# **BUCKINGHAM TOWN COUNCIL**

# BUCKINGHAM TOWN COUNCIL PLANNING COMMITTEE MONDAY 24th February 2020

Application 20/00483/APP Land to the rear of 2 Market Hill, MK18 1JS Proposed new detached building comprising 7 apartment dwellings and associated external works, bin/cycle store and alterations to access.

Previous application, Verney Close elevation

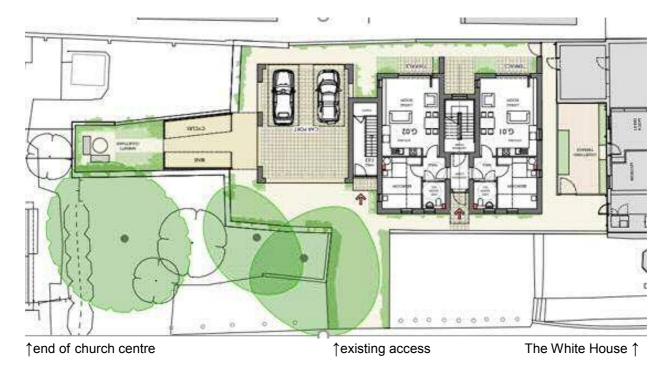
The building proposed was four storeys high, had three one-bedroom flats on each of the lower floors, with a two-bedroom flat on the top floor and a flat roof at the same height as that of the flats in the Bank building; there was no lift, and no parking.
